# PLANNING COMMISSION

**December 11, 2019 7:00 PM**

#### **1. SAKURA NOVI JZ19-31 WITH REZONING 18.732      [DETAILS](#)**

Public hearing at the request of Robert B. Aikens & Associates, LLC and Robertson Brothers Homes for Planning Commission's recommendation to City Council for a Zoning Map amendment from Office Service (OS-1), Office Service Commercial (OSC) and Light Industrial (I-1) to Town Center-1 (TC-1) with a Planned Rezoning Overlay. The subject property is approximately 15.59 acres and is located north of Grand River Avenue, south of Eleven Mile Road and east of Town Center Drive (Section 23). The applicant is proposing to develop the property as an Asian-themed mixed-use development.

**Figure 1.** City of Novi Regulated Wetland & Woodland Map (approximate parcel boundary shown in red). Regulated Woodland areas are shown in green and Regulated Wetland areas are shown in blue.

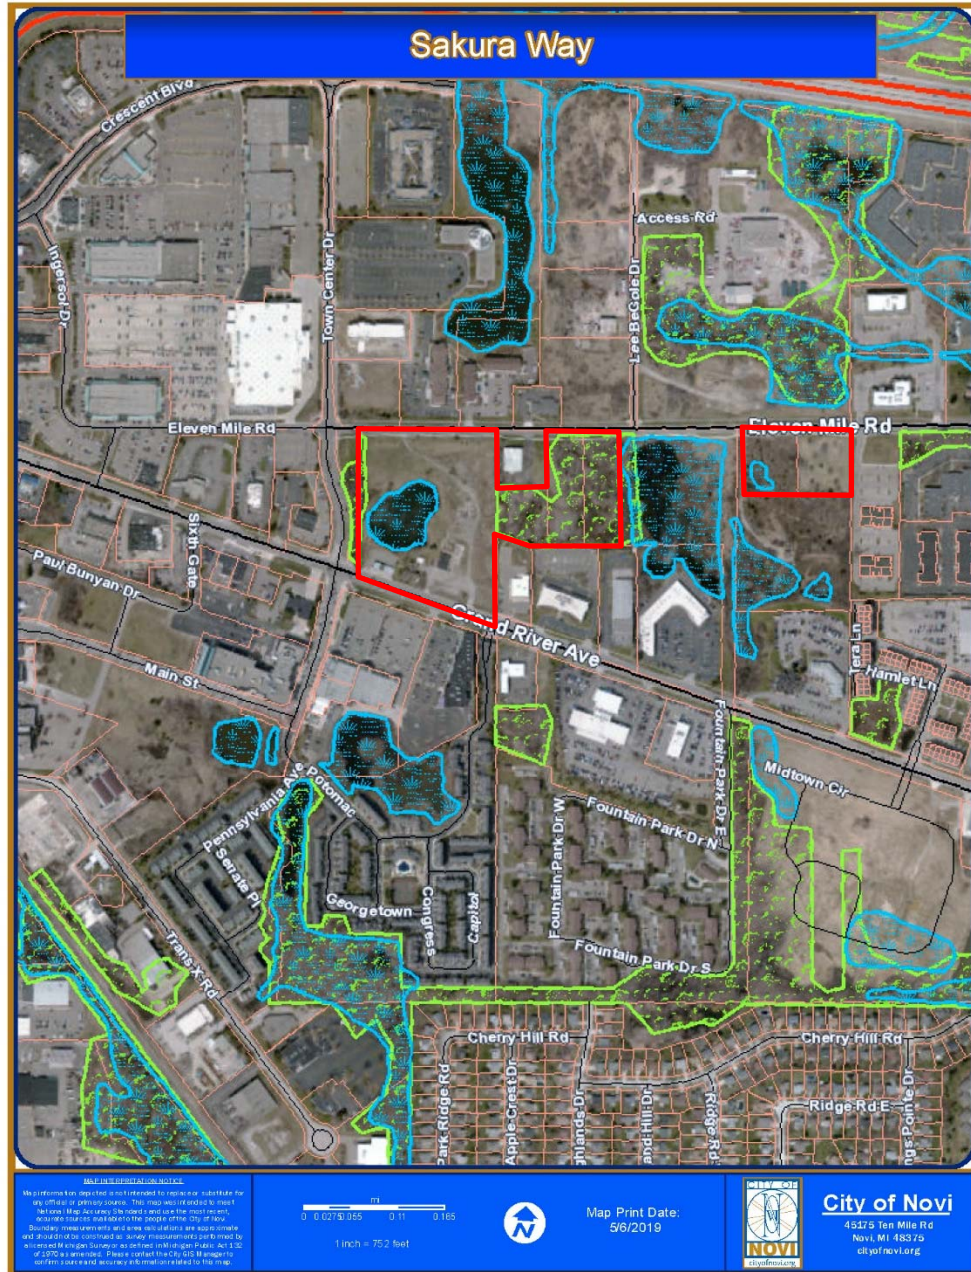
The majority of the central portion of the project site is indicated as City-Regulated Woodland on the City's Regulated Woodland Map (see Figure 1, attached). There is also area designated as Regulated Woodland along the western edge of the project property. The majority of the area that contains the open water pond/wetland (i.e. Wetland 2) is not indicated as Regulated Woodland. The parcels contained within Phase 3 of the project are also not indicated as City-Regulated Woodland. It should be noted that the purpose of the City of Novi Woodland Protection Ordinance (Chapter 37) is to:

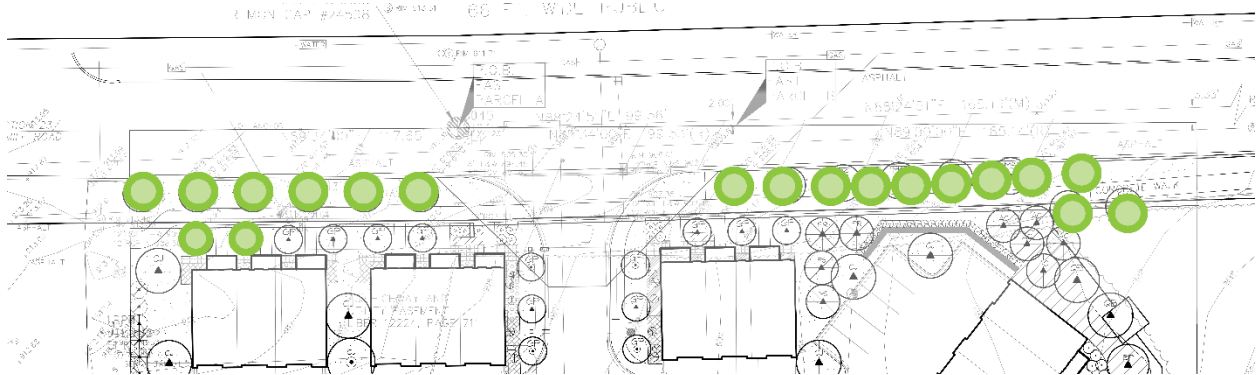
20 subcanopy trees are required. 11 subcanopy trees are provided in the right-of-way. Please provide the remaining required subcanopy trees. The deficiency in plantings is not supported by staff.

There is 362 LF of frontage along the residential portion of 11 Mile Road, 60 LF of which are adjacent to parking. Due to the 15' wide setback and presence of overhead utility lines, we propose 15 subcanopy trees within the ROW and the remaining 4 to be provided between the sidewalk and the bldgs.  $302/20=15.1$  (15 trees),  $60/15=4$  (4 trees). We will provide 19 subcanopy trees along the residential portion of 11 mile road. See graphic of approximate layout below:

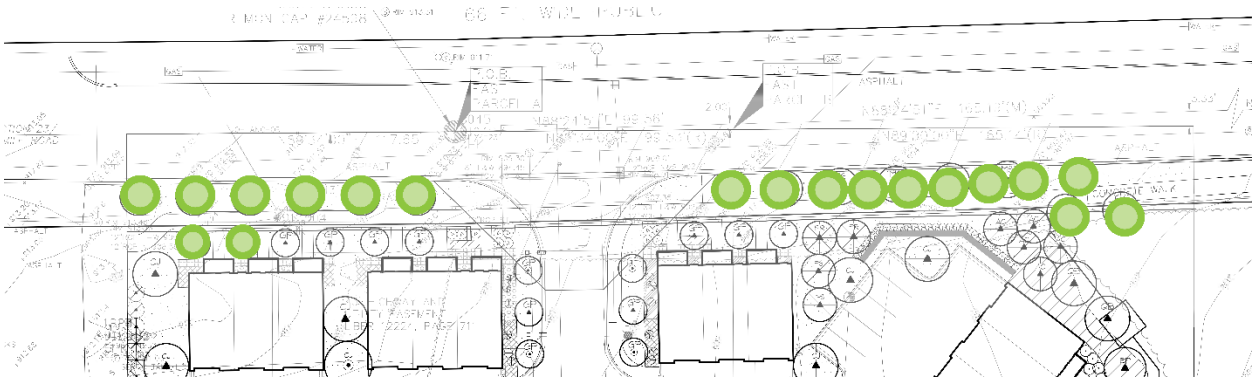
Please add as much foundation planting area around each building as possible to lower the extent of the deviation.

We are proposing additional building foundation landscape planting areas which meet some, but not all, of the requirements stated in the city ordinance. Per Section 5.5.3.D.g, *"With respect to projects within the TC and TC-1 districts, the Planning Commission may waive the 8 foot width calculation requirements if significant additional planting and/or decorative paving or amenities are added adjacent to the building."* The applicant will be appealing to the Planning Commission to waive the 8' calculation requirement as described in the ordinance.

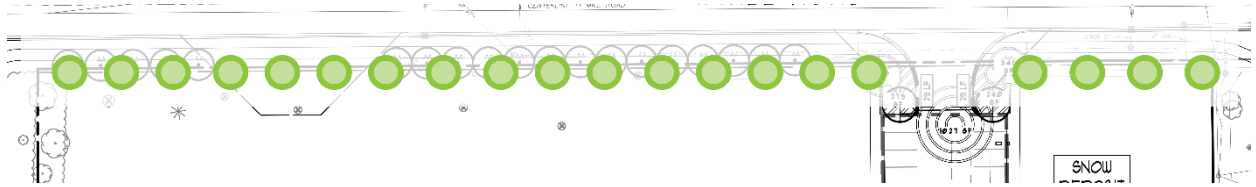
The mature width of the Freeman maple is 30-40' wide but they are spaced 15' o.c. Please space the Phase 2 greenbelt trees further apart (at least 25' o.c.)

All proposed Freeman Maple frontage trees will be spaced at 30' o.c. east of the entry drive, and 28' o.c. west of the entry drive. See Graphic Below:
